UCB Project Manager	David Byrne
Campus Standards Section #	B1011 – Structural Analysis and Design: Embedded Conduit
Type of Issue	Embedded Conduit in Level 1 concrete slabs
CU Standards Language	<i>Embedded Conduit:</i> <i>a. UCB cautions against embedding conduit within horizontal structural elements, even if such conduit is incorporated into the structural analysis. UCB experience indicates significant practical problems with overlapping conduit and large concentrations of conduit which cannot be accurately accounted for in the design phase.</i>
Variance Request	Conduits in level 1 structural slab

Type of Issue Embedded Conduit in concrete topping slabs above mass timber

Type of Issue Conductor Material

University of Colorado
Boulder
CHEMISTRY AND
APPLIED MATHEMATICS

Sheet Number
 E0.12
 Current Issue
 BID PACKAGE 02
 Current Issue Date
 05/29/2025

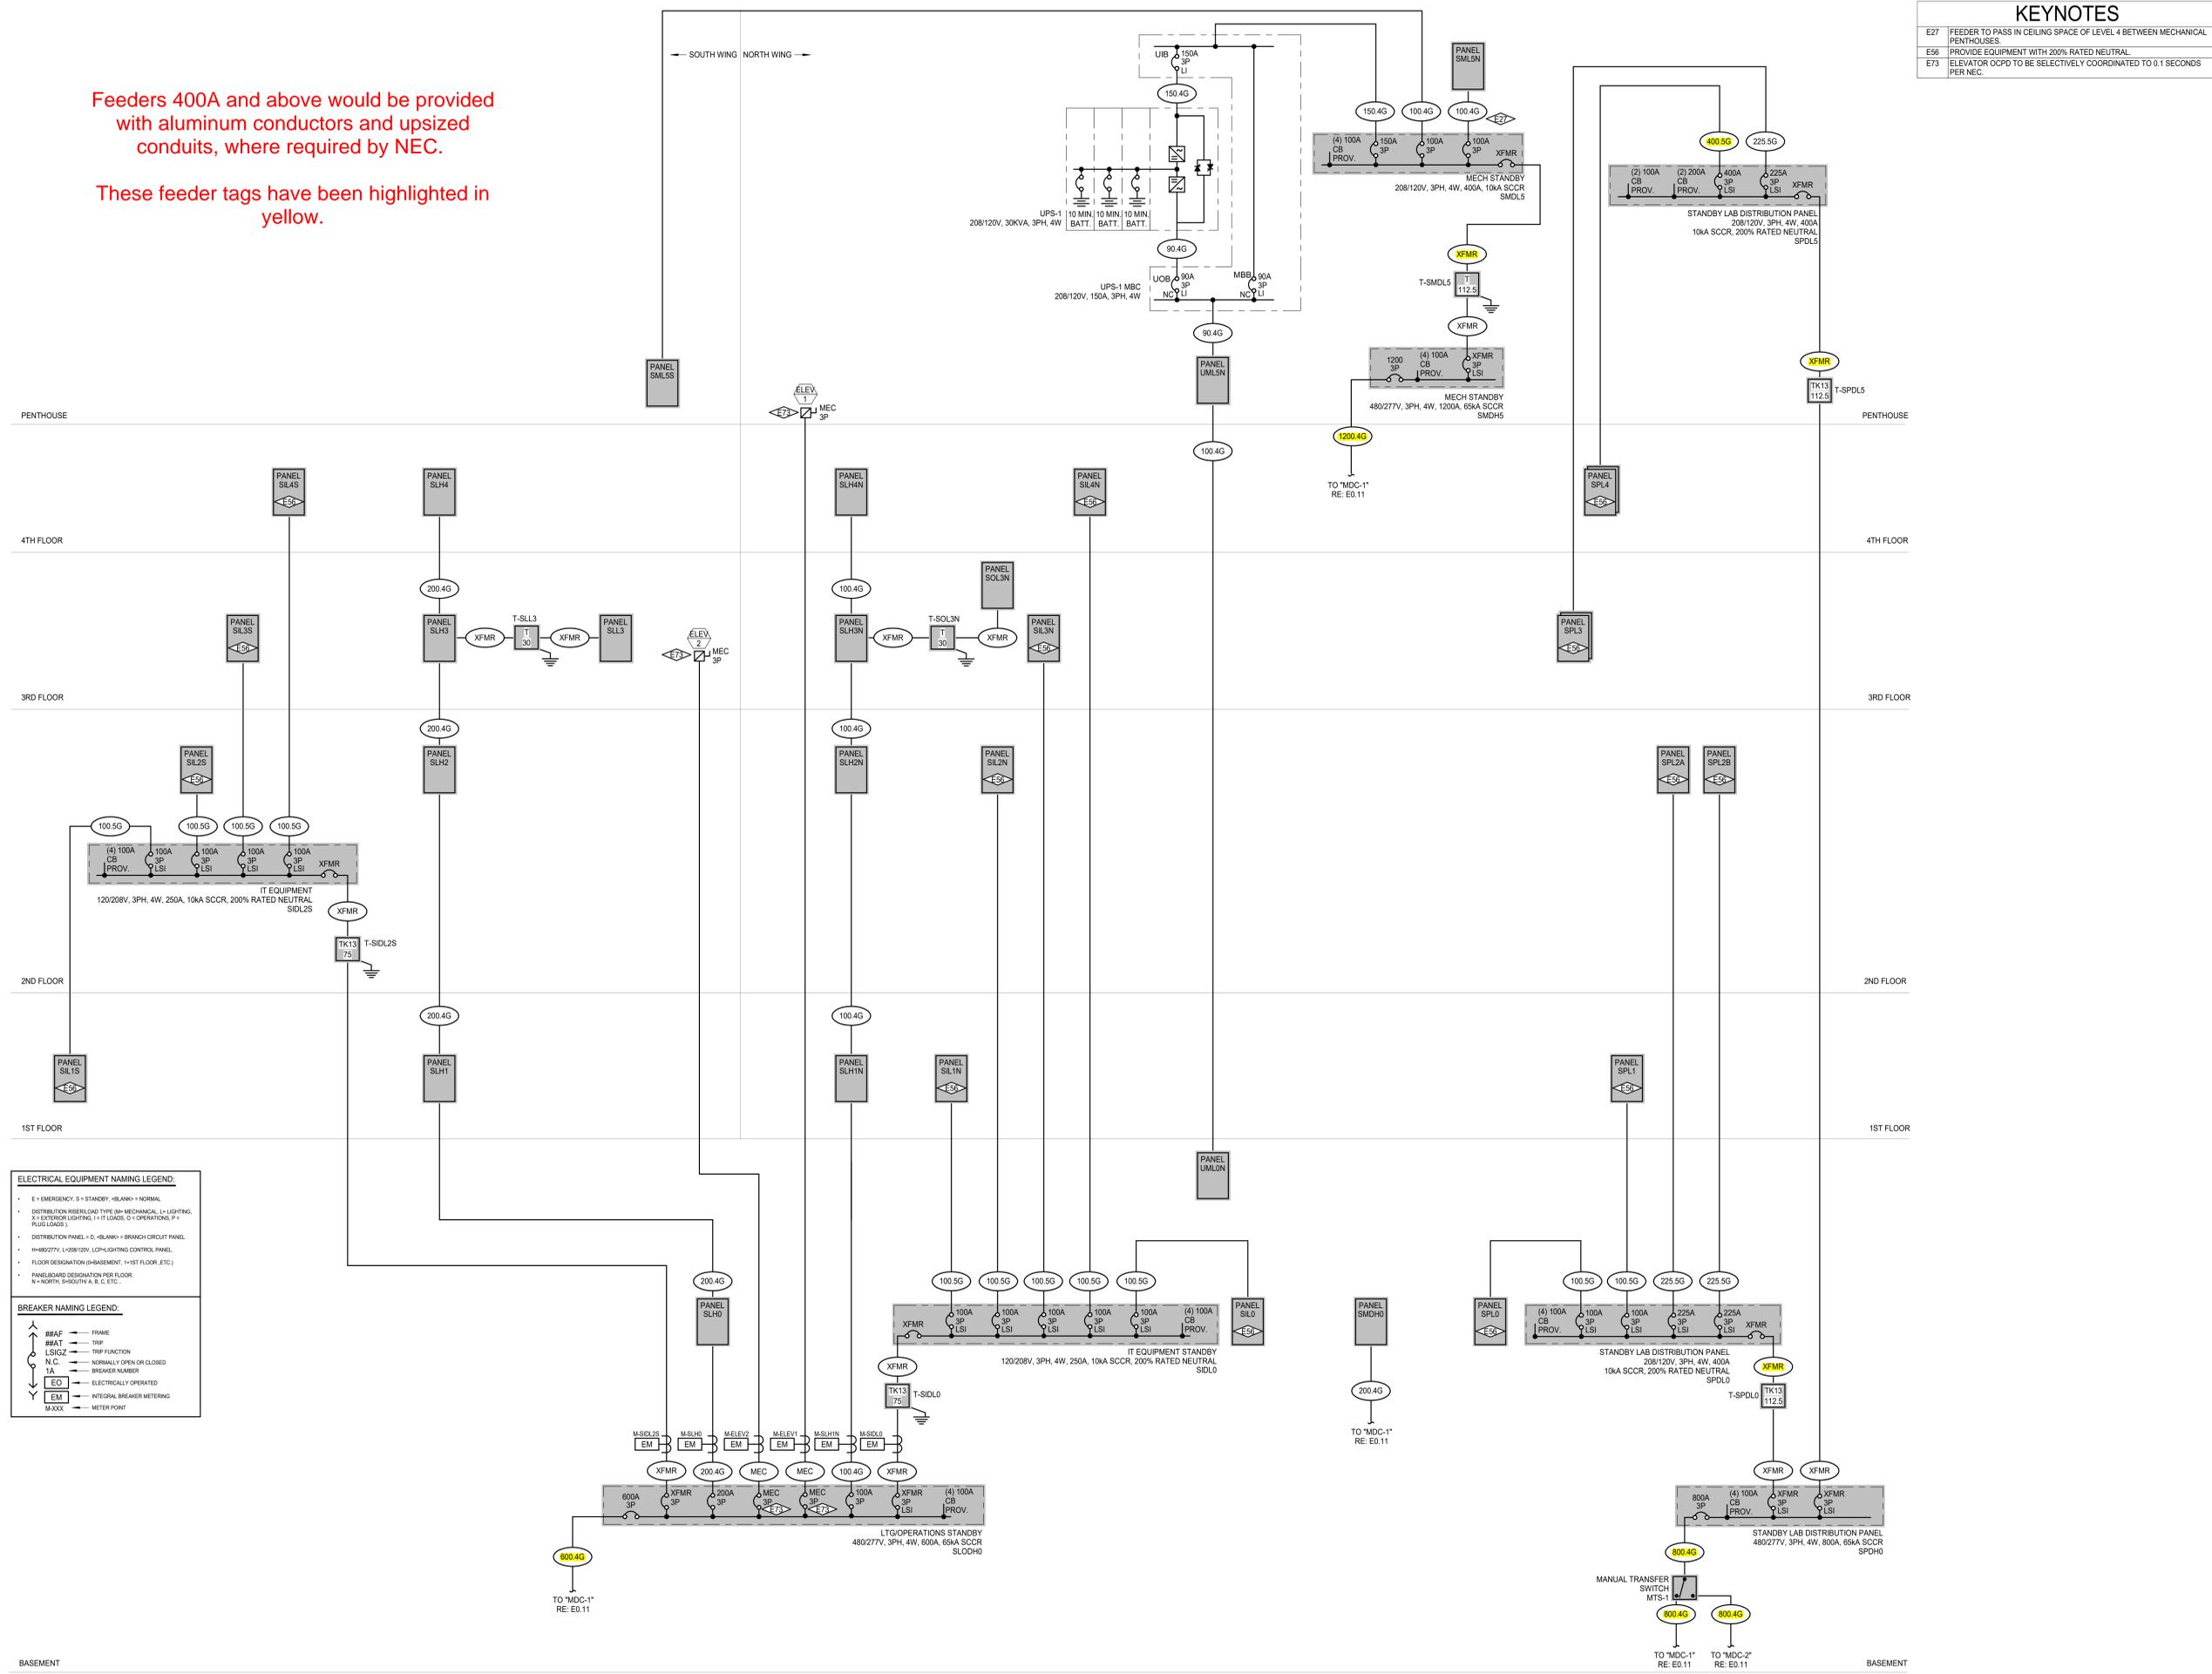
Feeders 400A and above would be provided with aluminum conductors and upsized conduits, where required by NEC.

These feeder tags have been highlighted in yellow.
